ADDENDUM No. 1 TO PLANS AND CONTRACT DOCUMENTS

**EAST MARSH ISLAND MARSH CREATION
POST-CONSTRUCTION MAINTENANCE EVENT**

CWPPRA NUMBER: TV-21

APRIL 4, 2014

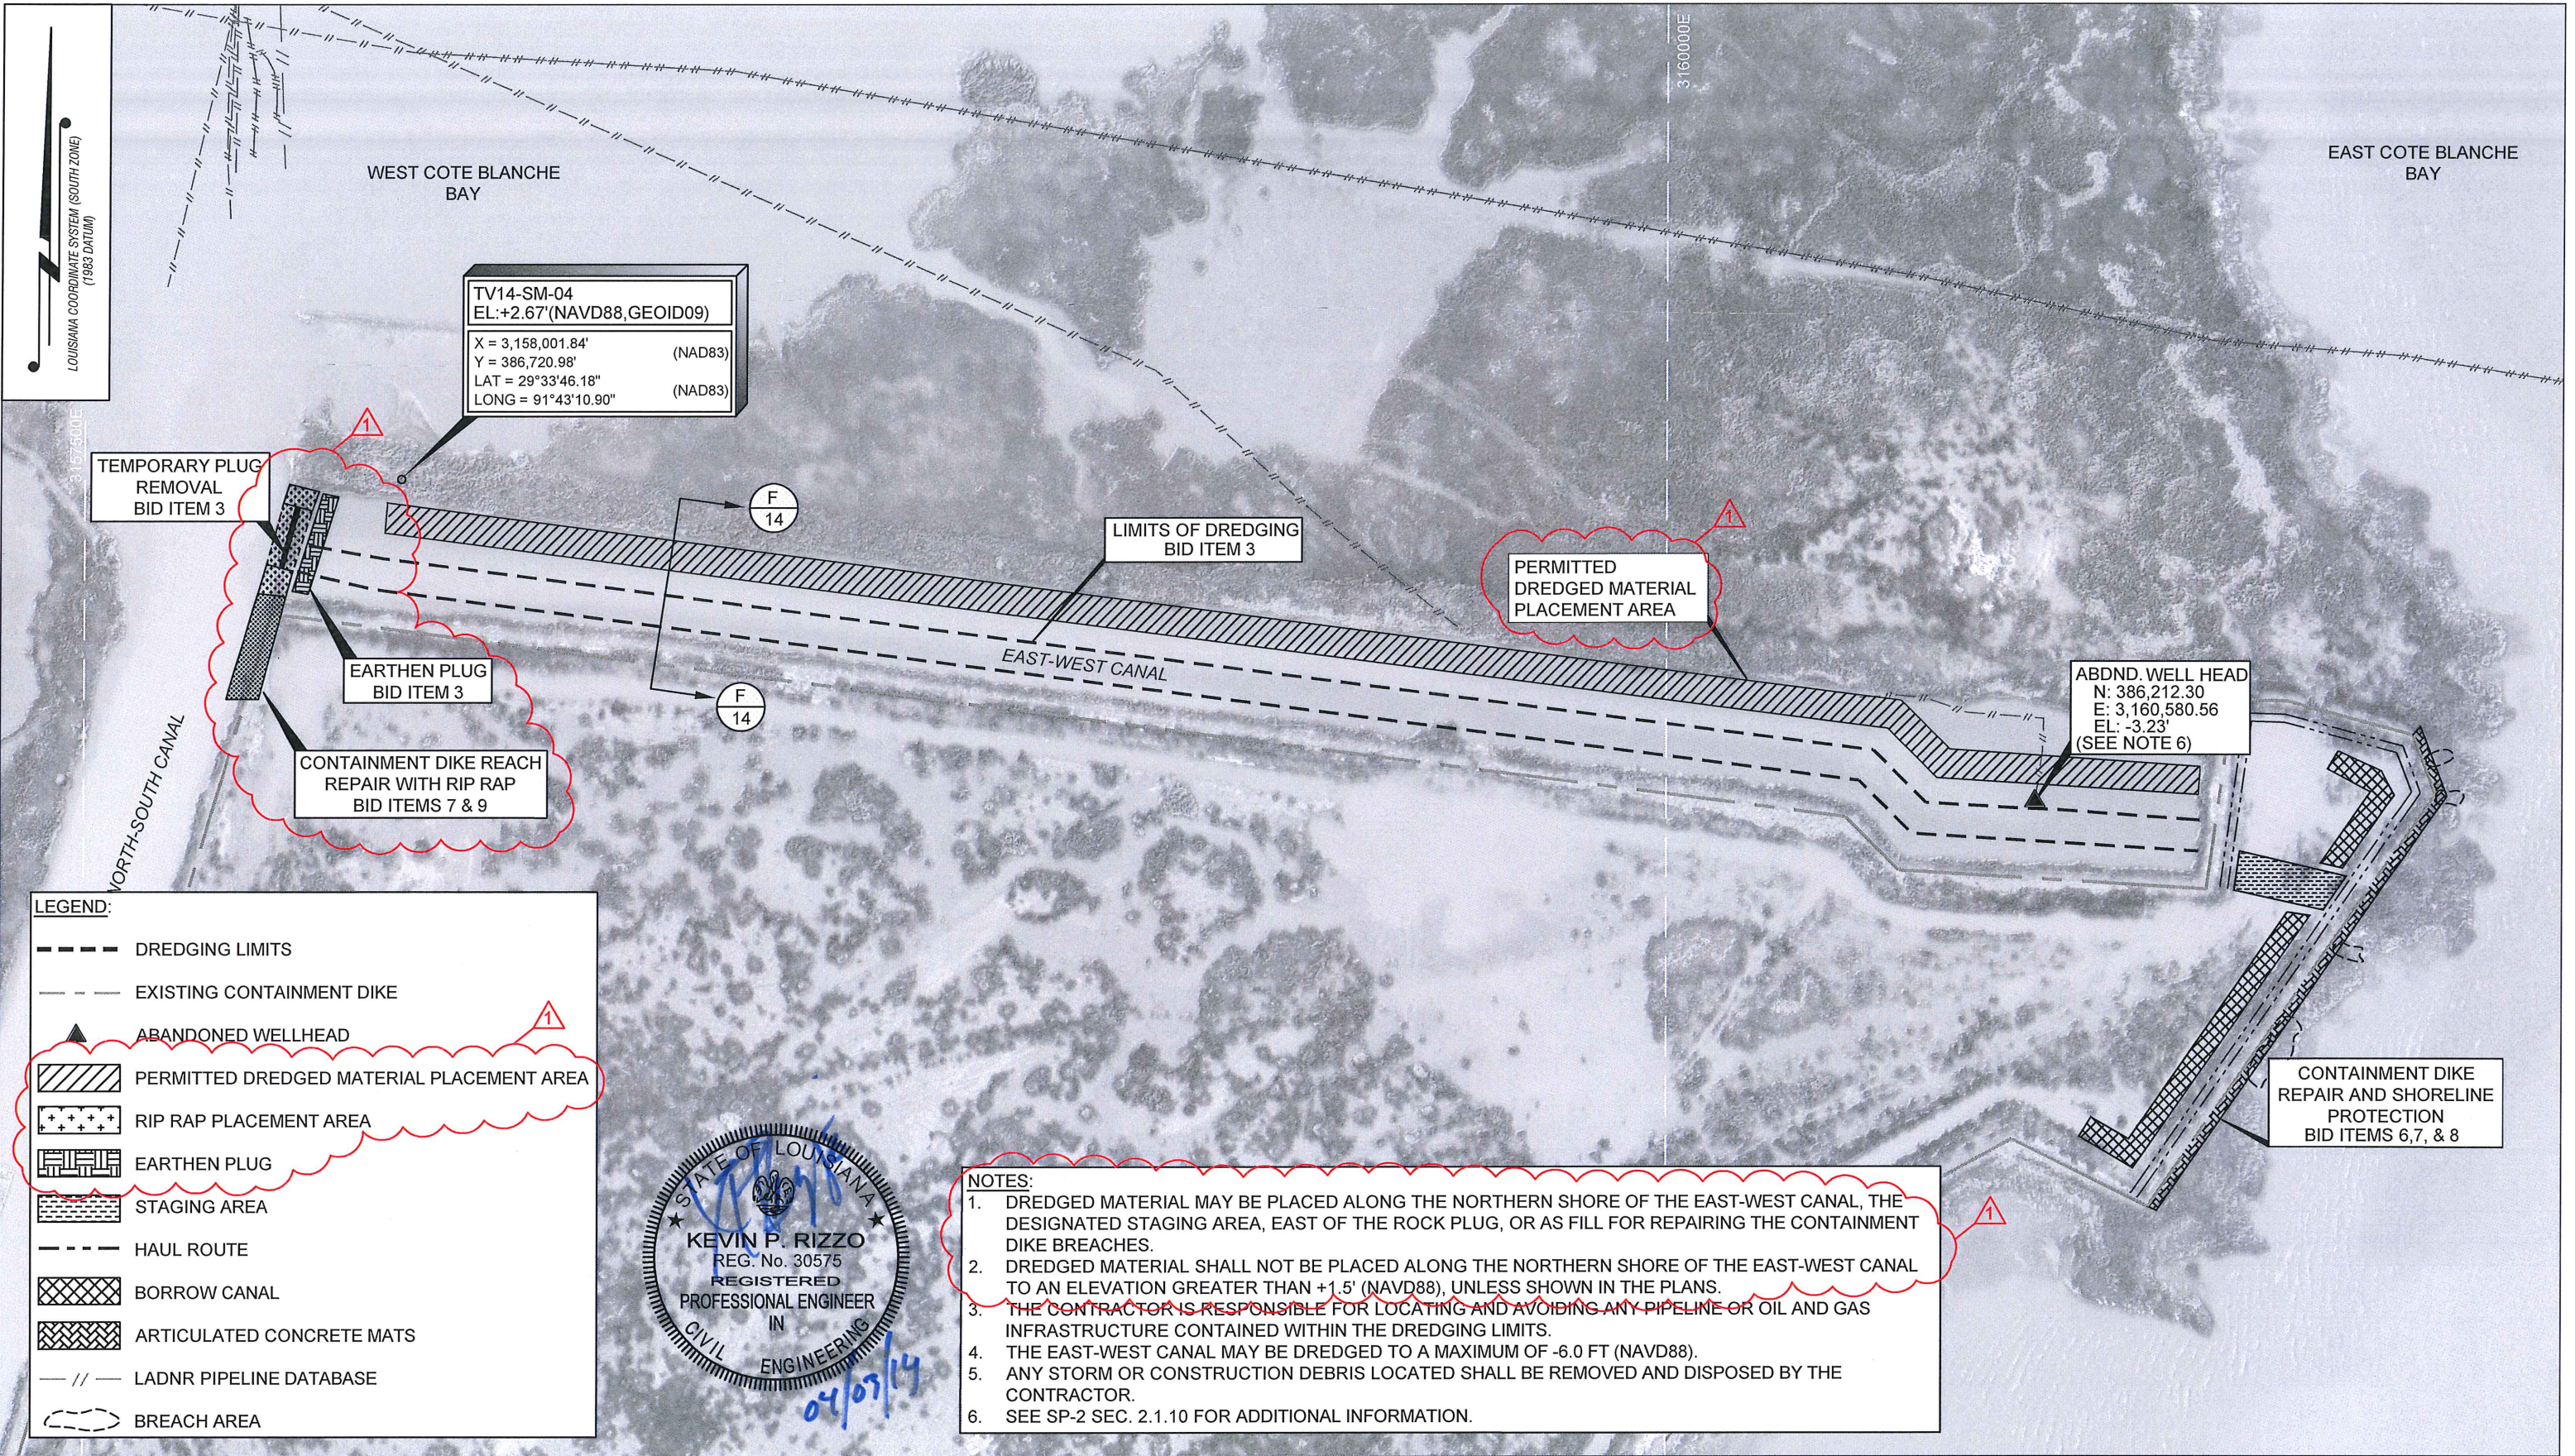
- 1.2. The proposed earthen plug just east of the rock plug being temporarily relocated (See Plan Sheets 6 & 7) has been resized. An earthen plug shall be constructed to a +1.5 ft. (NAVD88) with a minimum crest width of 25.0 ft. See Plan Sheets 6, 7, and 14 for details. Payment for the earthen plug shall be included in the lump sum Bid Item No. 3 “ACCESS AND FLOATATION DREDGING & PLUG REMOVAL”

TEMPORARY ROCK PLUG
REMOVAL AND BREACH
REPAIR LAYOUT

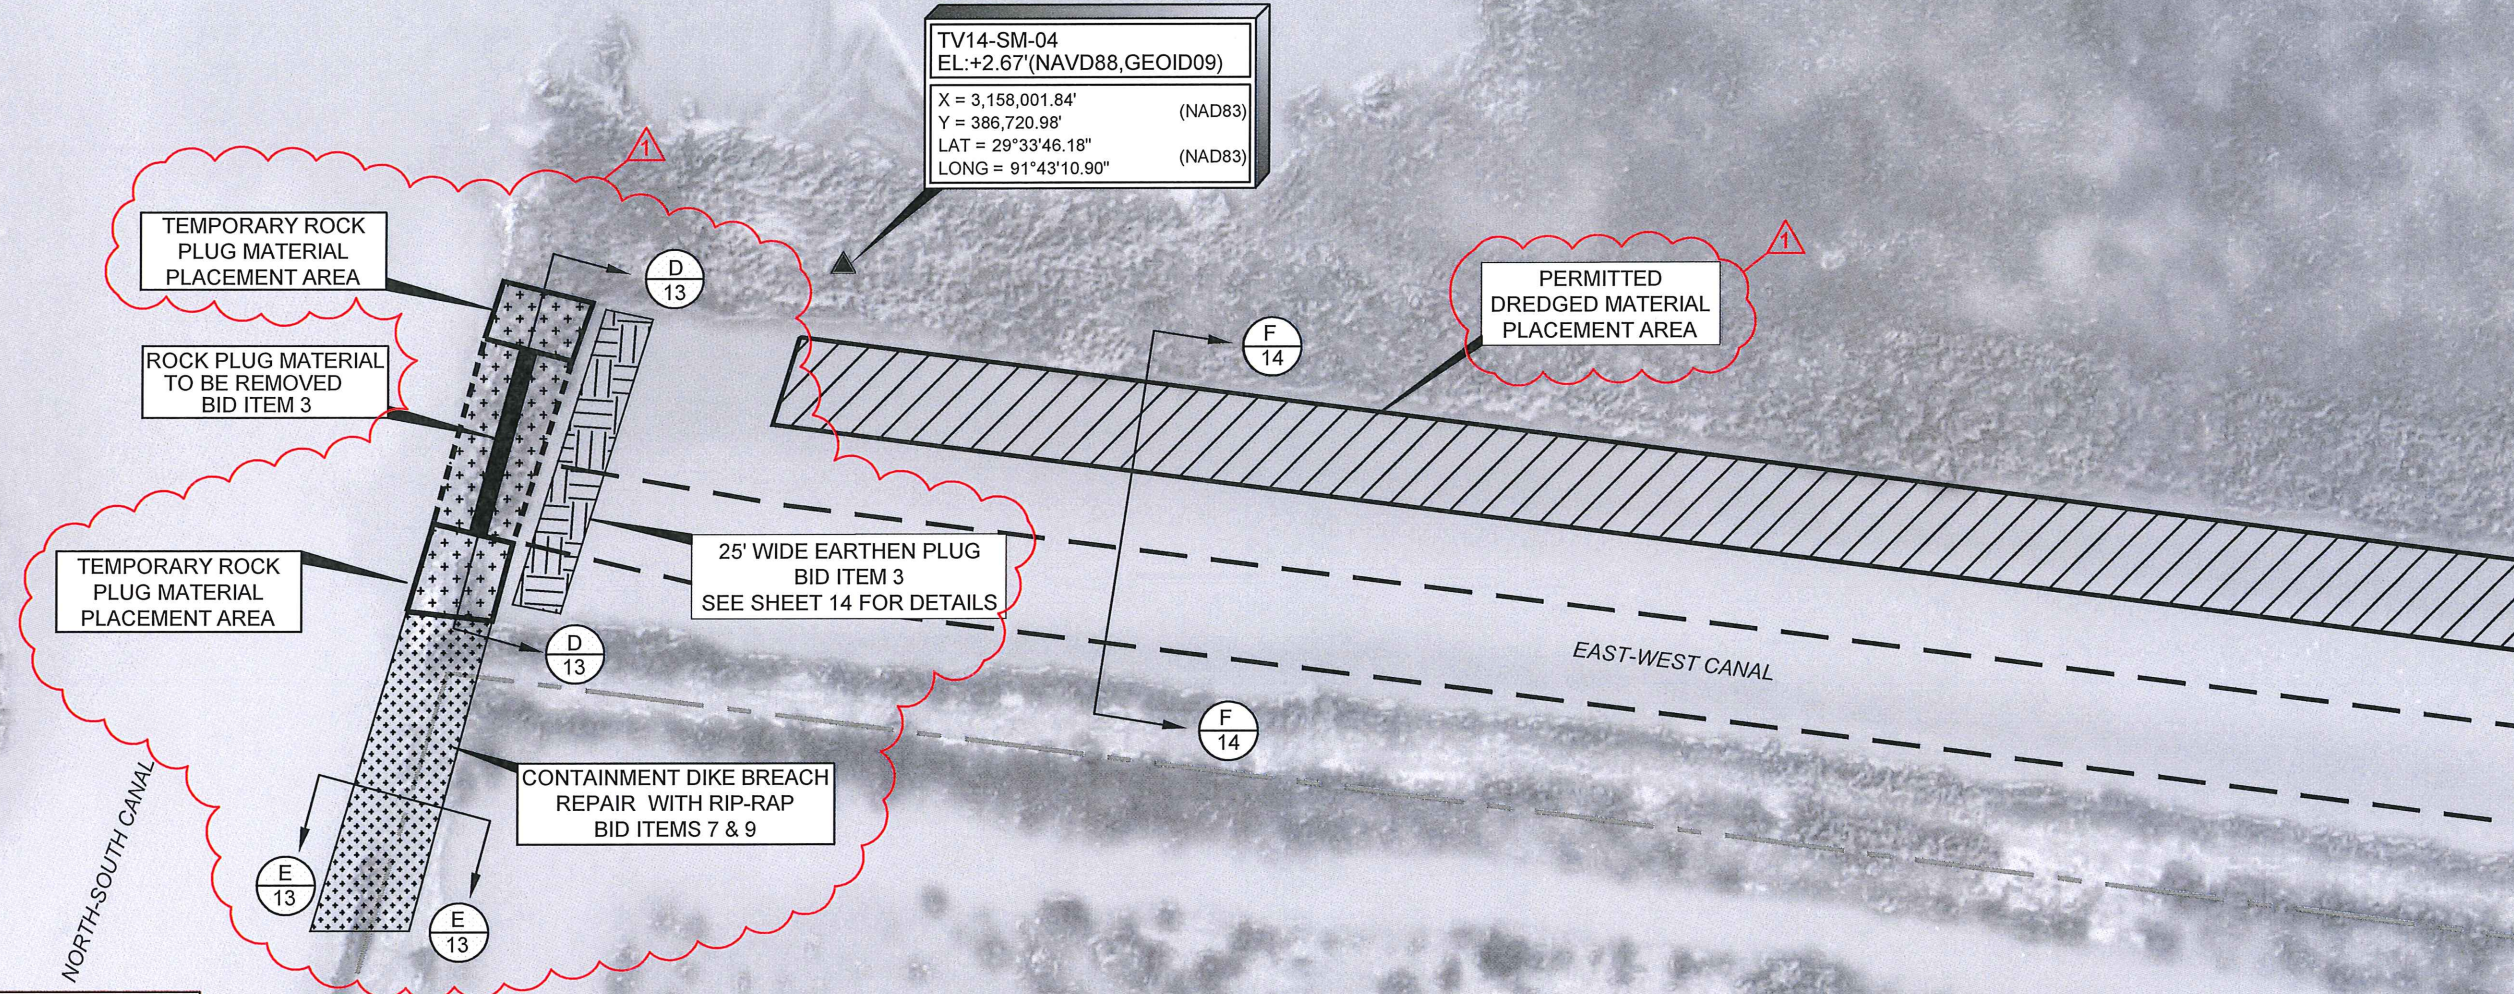
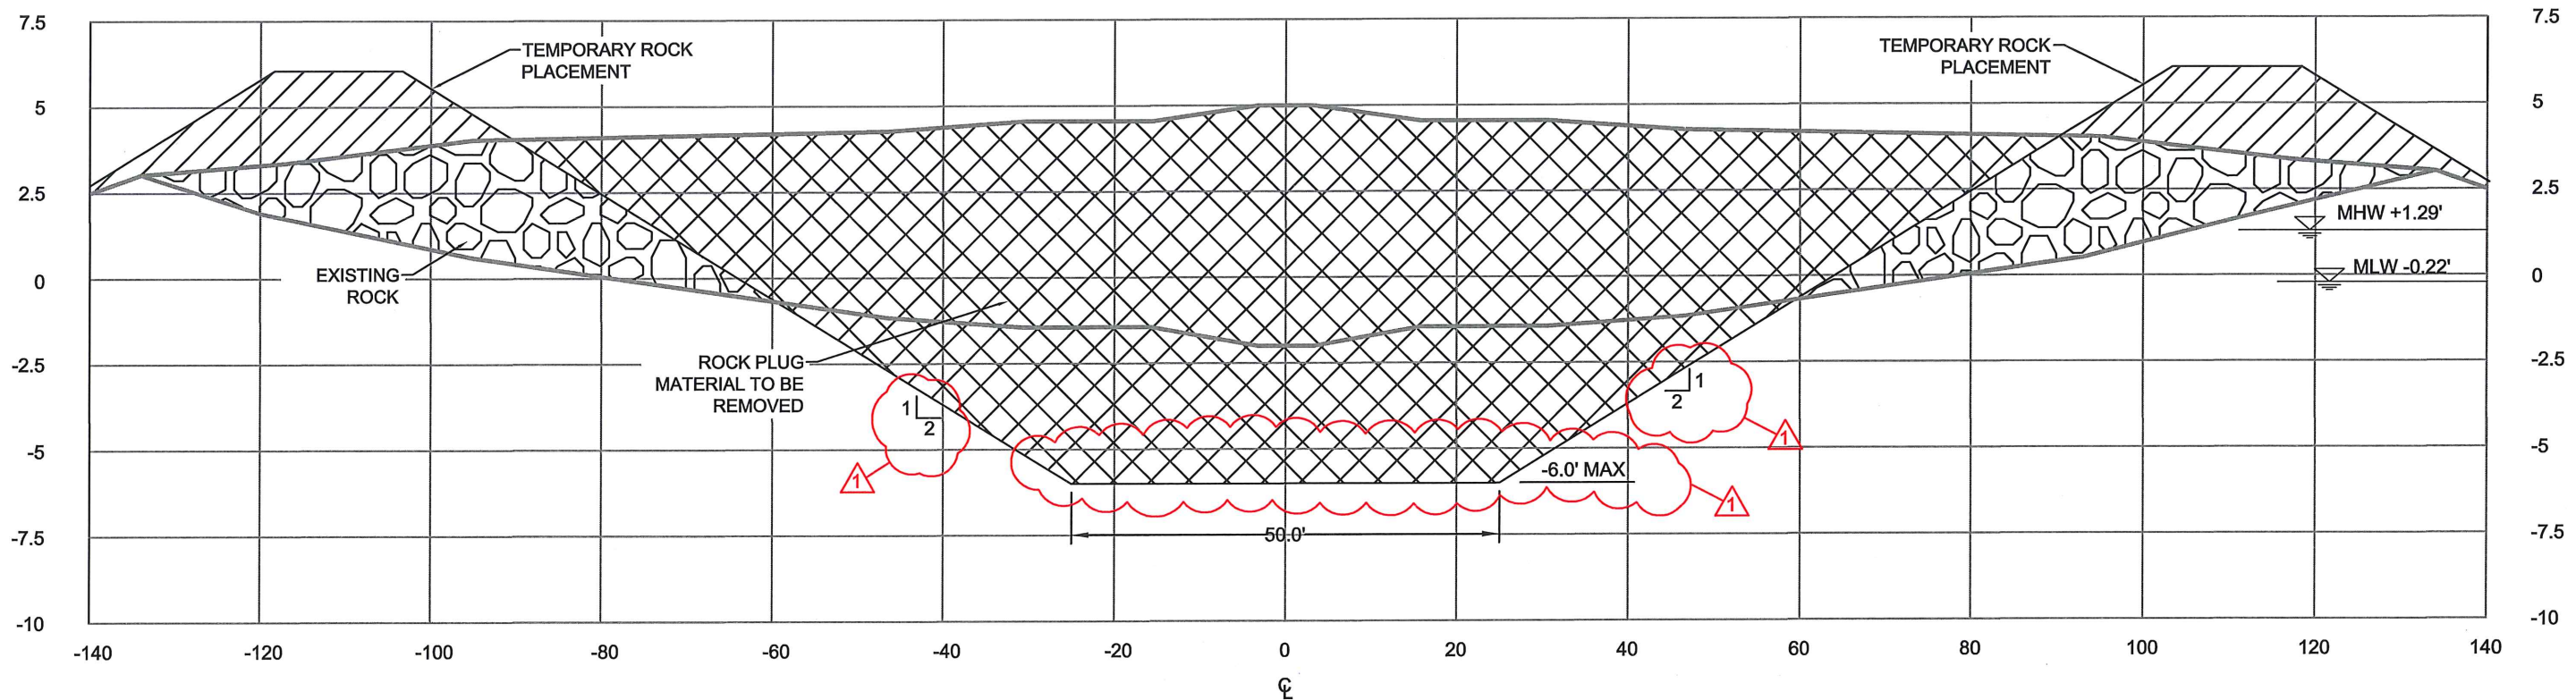
- 1.1. The Plans and Specifications will be updated to clarify the material replacement of the rock plug shall be **to** the pre-construction surveyed lines, grades, and elevations.

- THE ROCK PLUG IS TO BE RECONSTRUCTED WITHIN THE LINES, GRADES, AND ELEVATIONS OF THE PRE-CONSTRUCTION SURVEY PRIOR TO DEMOBILIZATION.
- EXCAVATED ROCK PLUG MATERIAL MAY BE PLACED ON AREAS ADJACENT TO THE EXCAVATION AS SHOWN ON THE PLANS.
- DREDGED MATERIAL FROM THE EAST-WEST CANAL SHALL BE PLACED TO CONSTRUCT AN EARTHEN PLUG WITH A 25' WIDE CREST WIDTH TO A +1.5' ELEVATION EAST OF THE REPLACED ROCK PLUG, PAID THROUGH BID ITEM 3.
- ANY EXCAVATED MATERIAL SHALL NOT BE PLACED AS TO IMPEDE NAVIGATION OF EXISTING WATERWAYS.
- DREDGING OF THE NORTH-SOUTH CANAL SHALL BE STRICTLY LIMITED TO WHEEL-WASHING OR MINOR DREDGING TO ALLOW DIRECT ACCESS TO THE ROCK PLUG.

TEMPORARY ROCK
PLUG REMOVAL &
BREACH REPAIR
TYPICAL SECTION D-D & E-E

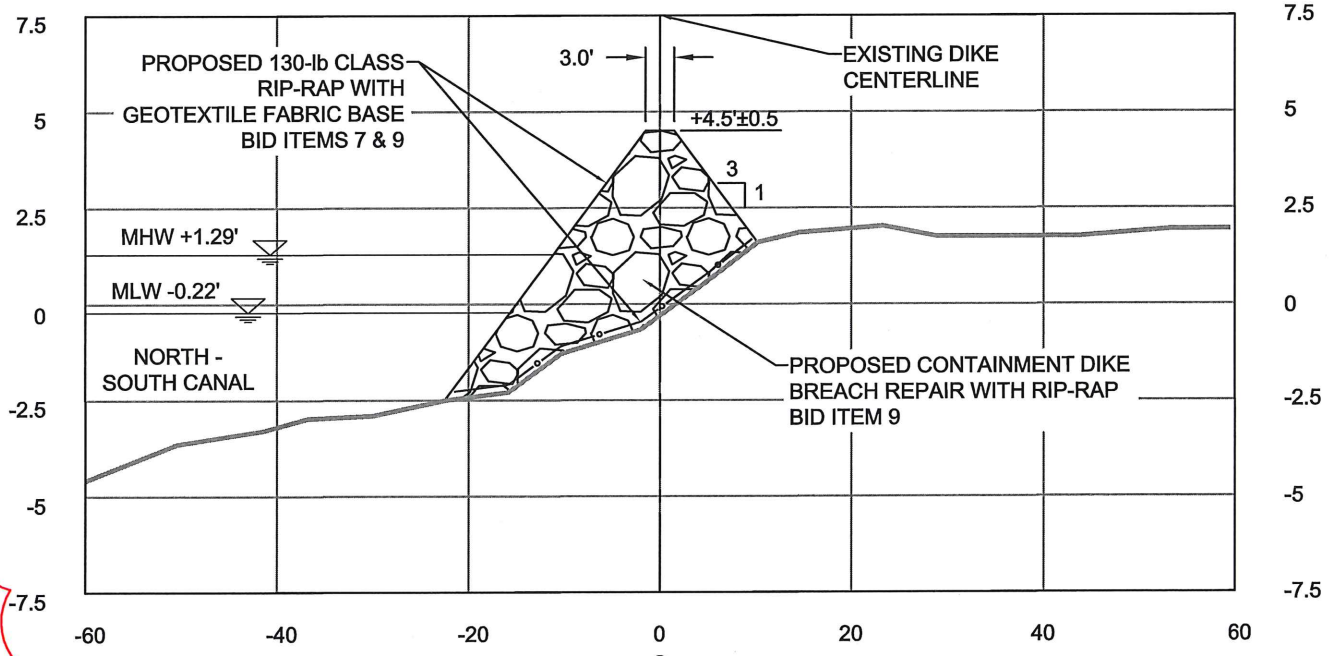
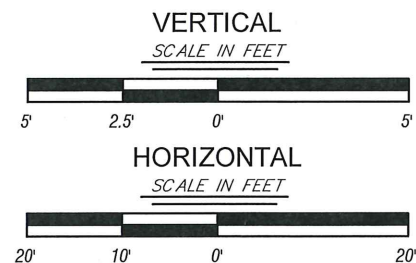
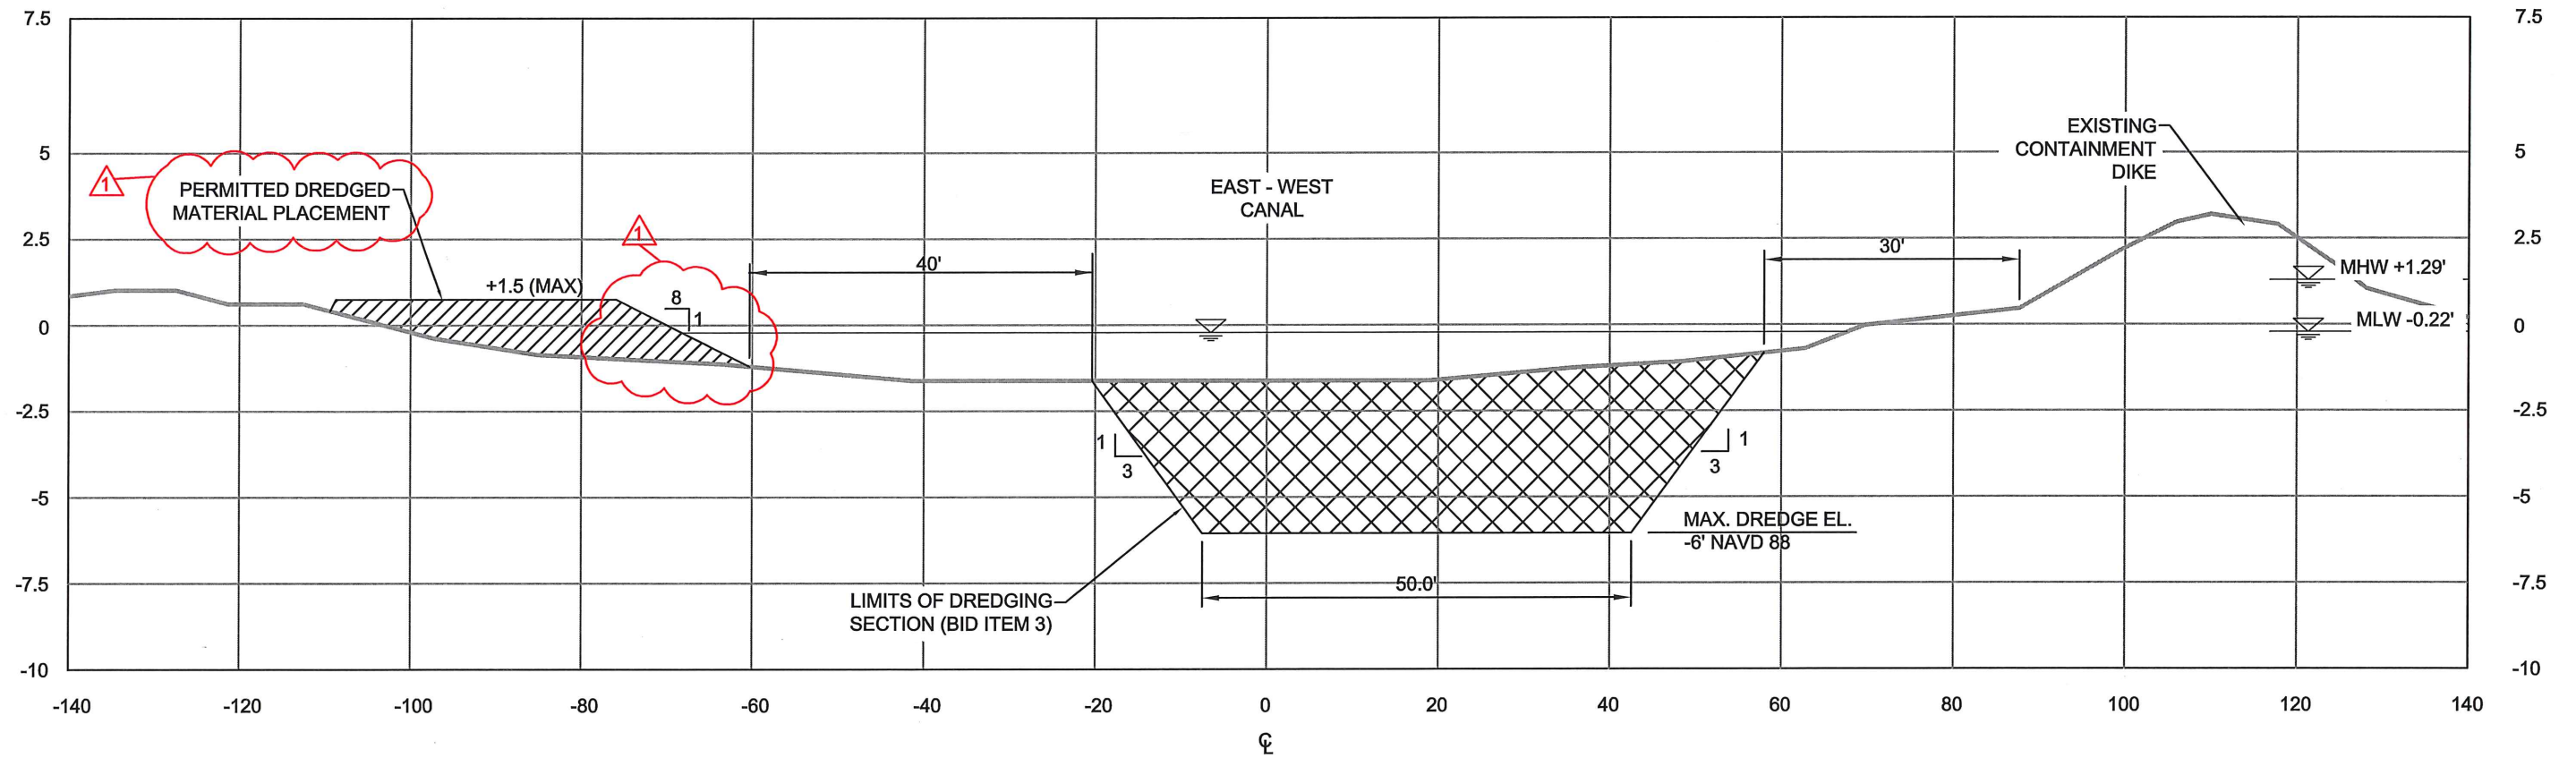
3.5 Rock Plug Material Replacement: *Excavated material from the rock plug shall be replaced to the lines, grades, and elevations surveyed during the pre-construction surveys. Material lost during removal and replacement shall be augmented with additional rip rap in accordance to TS-9 of these specifications. Measurement and Payment of additional rip rap shall be included in Bid Item TS-9.*
